Project	IEEE 802.16 Broadband Wireless Access Working Group < http://ieee802.org/16 >	
Title	Clarification on the credit token based co-existence protocol principle	
Date Submitted	2006-09-22	
Source(s)	David Grandblaise Motorola Labs Parc Les Algorithmes Commune de Saint Aubin 91193 Gif sur Yvette, France	Voice: +33 (0)1 6935 2582 Fax: +33 (0)1 6935 4801 mailto: david.grandblaise@motorola.com
Re:	Recirculation of Working Group Review of Working Document 80216h-06_015r1	
Abstract	This contribution provides clarification to comment #1104 (action item) of the session #44's Working Group Review [3]. This contribution proposes some preliminary text remedies on the credit token based protocol principle related to co-existence conflicts avoidance. The proposed text remedies are intended to be included in sections 15.4.2.5.3, 15.4.2.5.4 and 15.5.2 of the working document [1].	
Purpose	Clarification to comment #1104 of the session #44's Working Group Review. Text remedies are proposed for sections 15.4.2.5.3, 15.4.2.5.4 and 15.5.2 of the working document [1].

Clarification on the credit token based co-existence protocol principle

This contribution provides clarification to comment #1104

Figure h45—Dynamic (iterative) credit tokens based scheduling cycle (sequences (1) to (5))

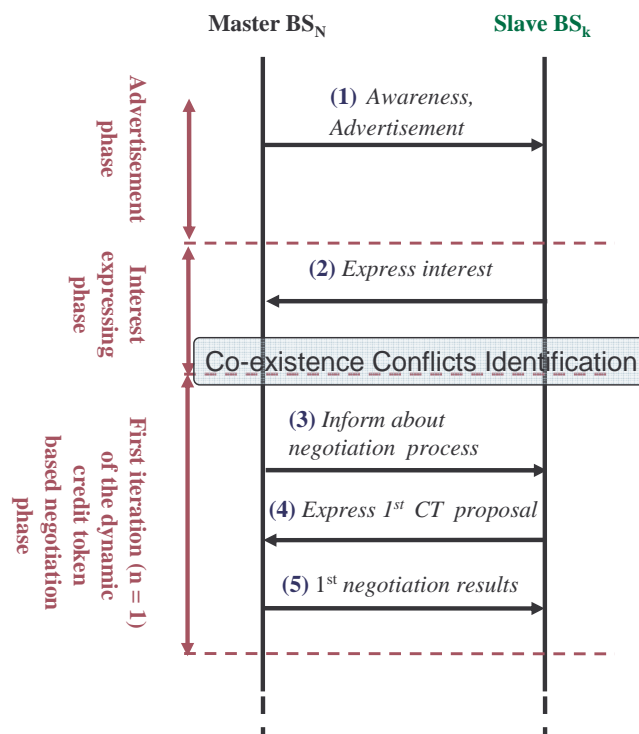
Remove the current Figure h45 of [1] and replace by the one below:

Figure 7: Process of co-existence conflicts identification

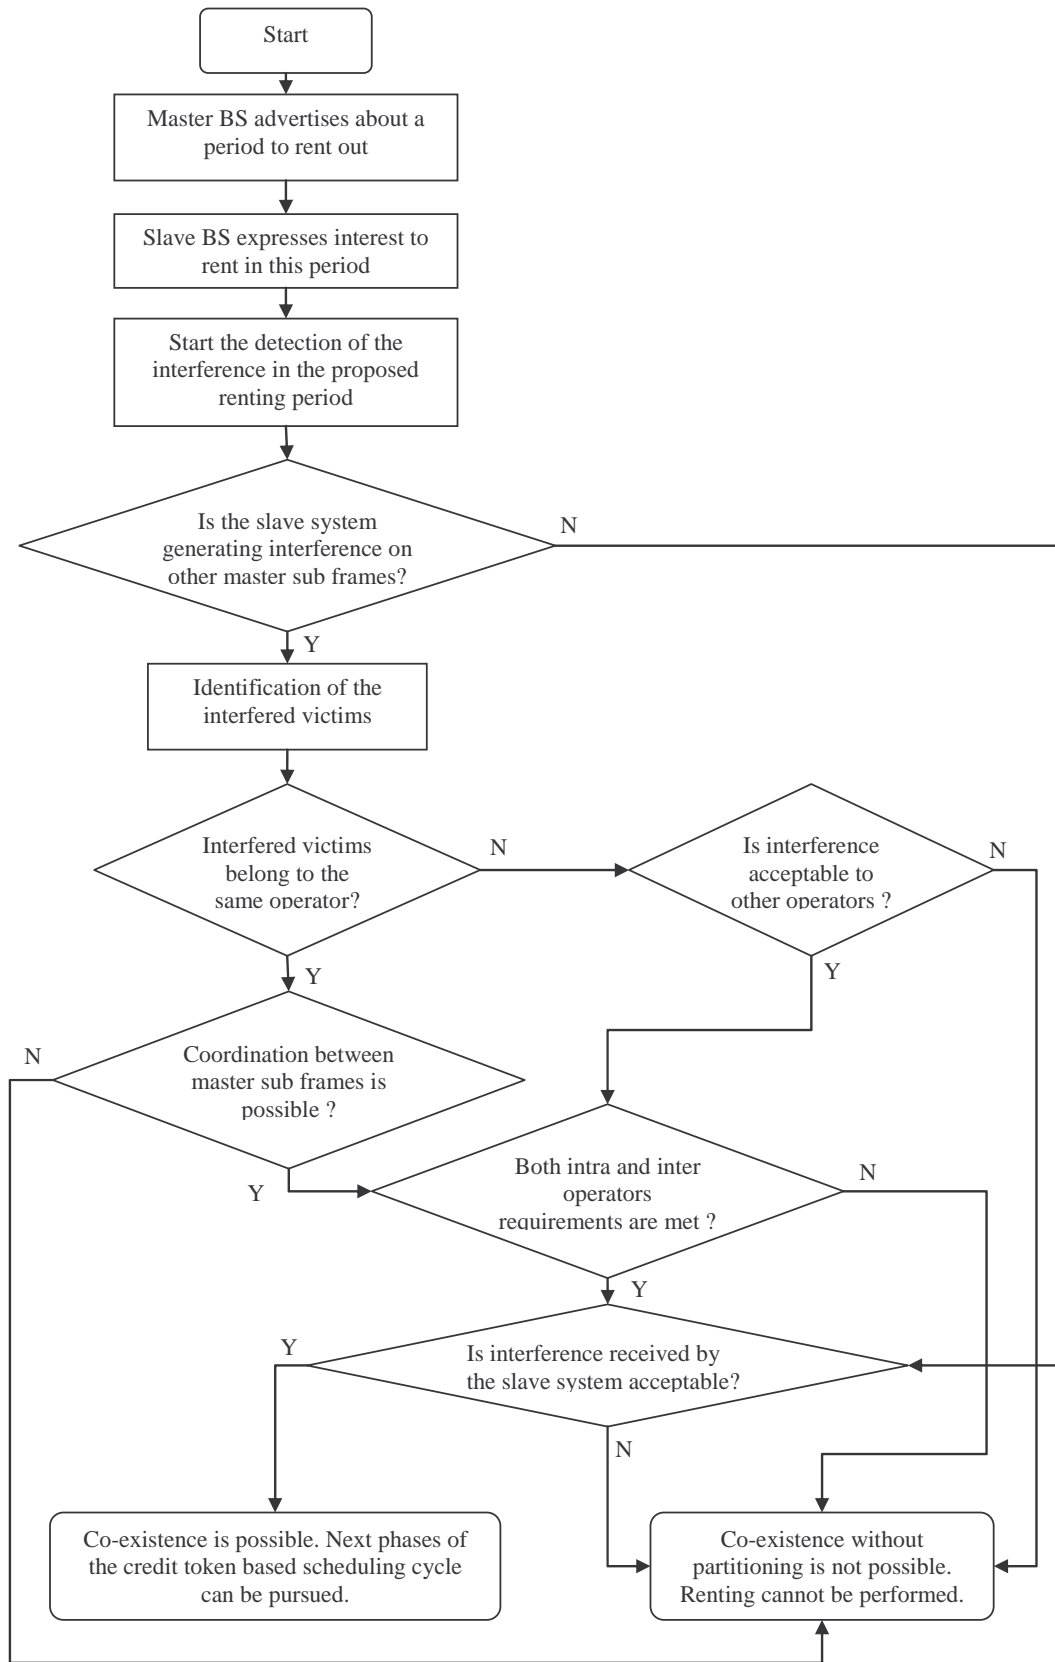
Figure 7 shows the process used to identify the possible co-existence conflicts that could appear if the renting between a master BS and a (or several) slave BSs occur. This process is done prior the renting is actually made. If the co-existence conflicts can be resolved, sequences from (3) to (10) of the scheduling cycle (Figure h45 and Figure h46) are executed. Otherwise, the cycle is stopped and the renting will not occur.

Figure 7 takes into account of the co-existence conflicts between the master sub frames operated by a same operator, or by different operators.

After the master BS has advertised about a period (part of its master sub frame) to rent out, and after some slave BSs have expressed their interest to rent in this period, the identification of the interference in the proposed renting period starts. Each of these slave systems follows the interference detection process described in the flowchart. Based on the interference detection and identification mechanisms of sections 15.3 and 15.4.2.1.2 (radio signatures), each slave system is able to know if it is interfering some other master sub frames (not the one under renting). With respect to this, it can know if there are some co-existence conflicts. In case the conflict is with a master sub frame operated by the same operator, this operator can check if the interfered master sub frame can have the same time duration and starting time as the one proposed for renting. In that case, co-existence conflicts disappear. In case the conflict is with a (or several) master sub frames operated by a (or several operators), it is checked if the interference level in these master sub frames is acceptable. If not, co-existence conflicts cannot be resolved, and the renting process is stopped. In case this level is also acceptable for these other operators, the process goes on. The next step consists in checking if the slave system can support any interference originated from these master sub frames. If the slave system can support this interference, co-existence conflicts can be handled, and next steps of the credit token based scheduling cycle can be pursued.
